RESEARCH ARTICLE

Towards an off-grid fecal sludge treatment unit: demonstrating energy positive thermal treatment [version 1; peer review: 2 approved, 2 approved with reservations]

Figure 1. The Biogenic Refinery Combined Heat and Power system uses thermal energy produced through the thermal treatment of feedstocks to generate electrical power using an organic Rankine cycle generator (black dashed box).

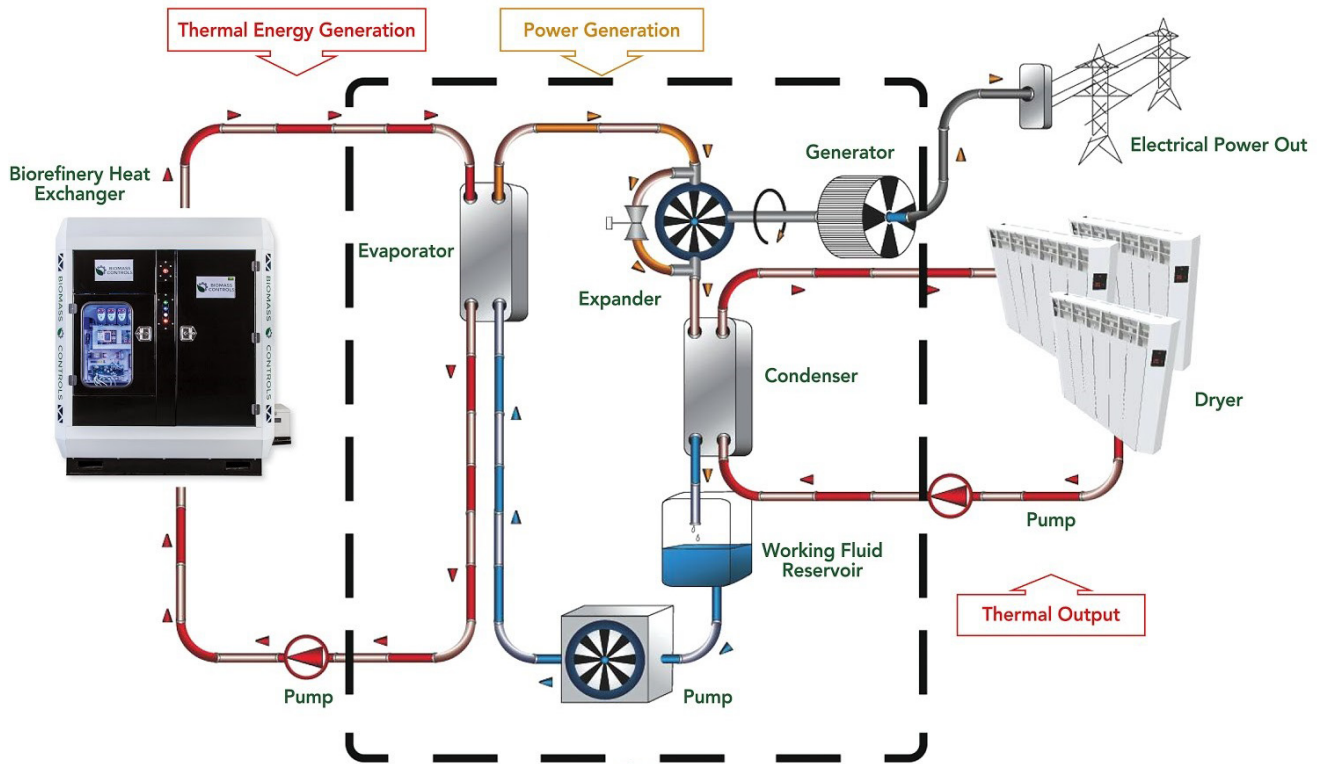
- I find the description of the operation of the system to be very confusing and Figure 1 does not clarify the system sufficiently. Where on Figure 1 is the pyrolysis/combustion occurring? Where are the stack gases directed? Do they go through the oil heat exchanger first, and then through the hydronic system? The authors should label each working fluid in the loops on the diagram. In addition, I do not see the hydronic heat exchanger module on the figure. What are the “Dryers” on the figure?
- The authors should state typical pressure and temperature values in their work of the oil, water, and ORC working fluids.

- The sentence prior to Eq. 7 has an extra "is". Same comment about density and specific heat being functions of temperature as for Eq. 4.
- The sentence "During steady-state operation, water, oil and air temperatures of gases" does not make sense to me. Can the authors clarify? The authors should label the location of each

thermocouple/thermistor on Fig. 1.

- Figure 1: The captions of figures are conventionally written without any conjugated verbs.
 - Section “Feedstock”, paragraph 2, first sentence: The moisture content of 35% is too low to be from a raw faecal sludge. So, I think that you are referring to previously dewatered or dried sludge. You have to specify this.

Figure 2. A Sankey diagram of energy flow of the Biogenic Refinery Combined Heat and Power unit during steady-state operation.

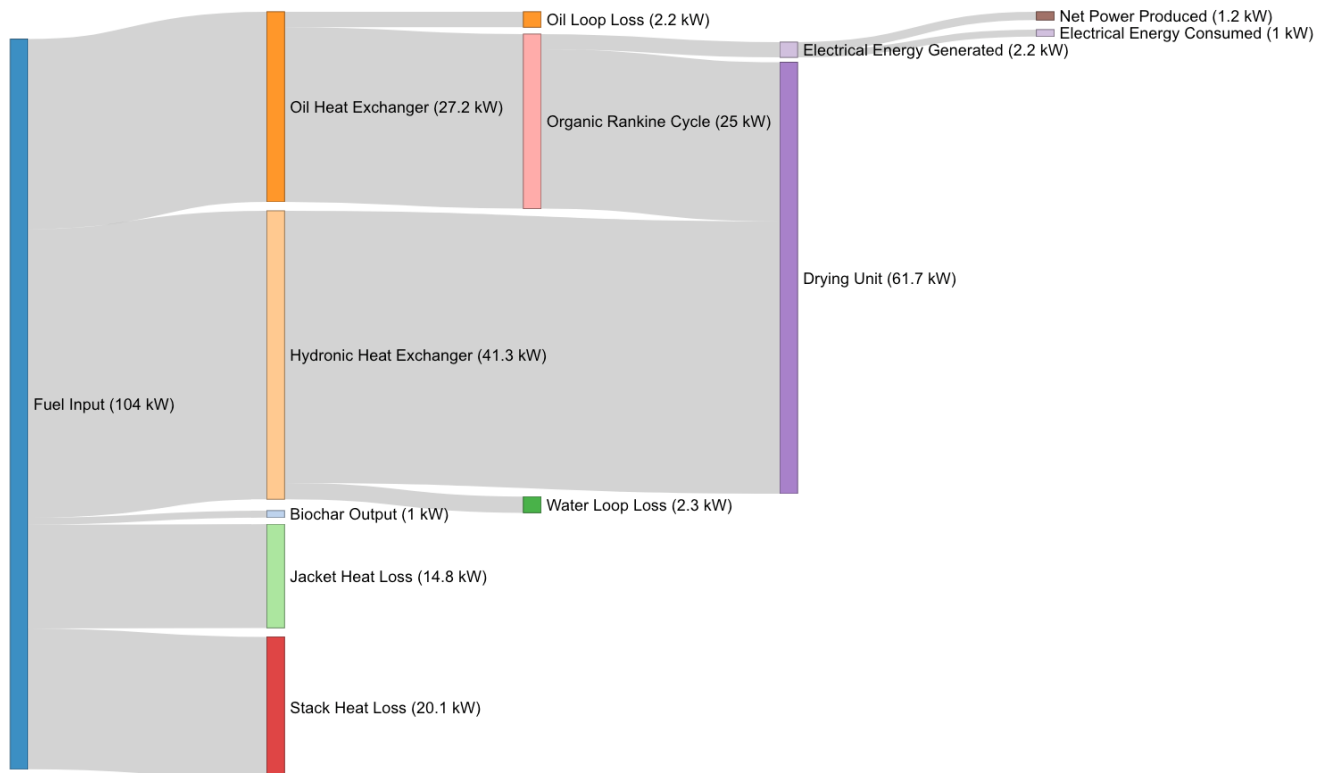
- The Sankey diagram in Fig. 2 includes electrical energy output, but the authors stated that the ORC was taken out of the loop for the thermal power balance test. This seems inconsistent and the authors should please clarify. The authors note in the text that the fuel input power is 104.5 kW but only show 104 kW on the diagram, although other numbers are specified to one decimal place. The authors should be consistent.

- What information is present in this table and figure that isn't present in Fig. 2?

Figure 3. Thermal power balance of the Biogenic Refinery.

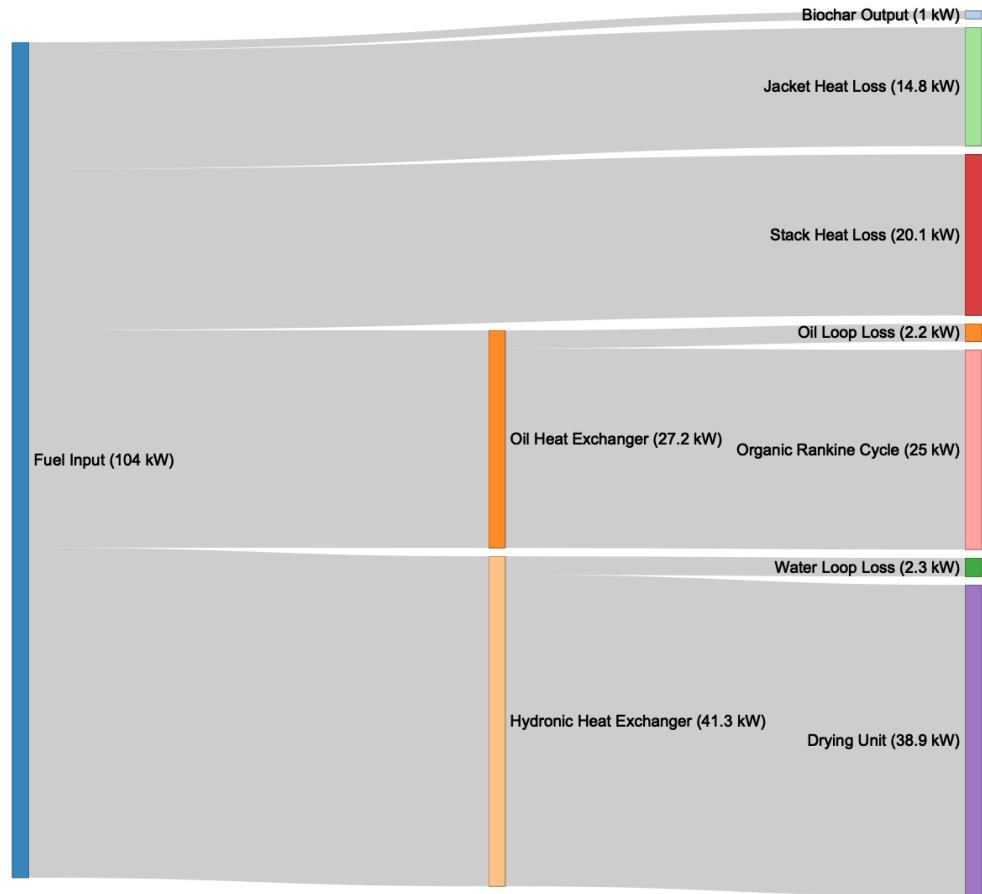
- Also include the thermal properties of water, as you did for oil.
- There is unnecessary repetition in presentation of results. Information on Figure 3 can be got from Figure 2.

Figure 4. Electrical power balance of the Organic Rankine Cycle.

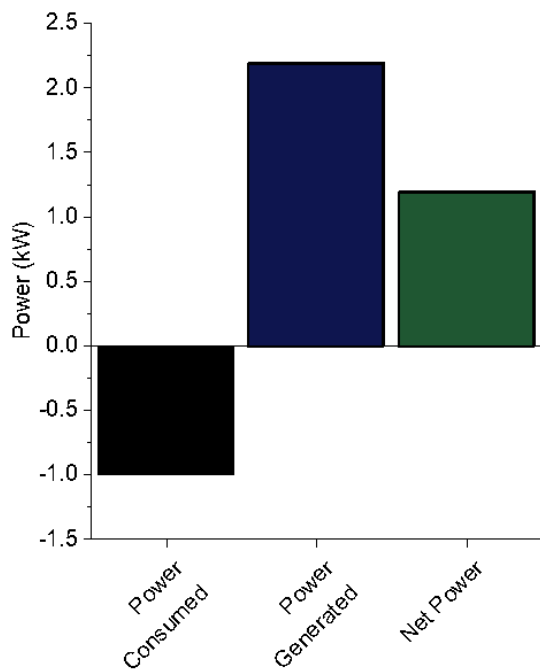
- How is the power draw of the system calculated? Does it include all the fans, pumps, electronics, and other accessories necessary to run the system, including the oil, water, and working fluid pumps? I don't think that Fig. 4 adds anything to the manuscript and could be removed.
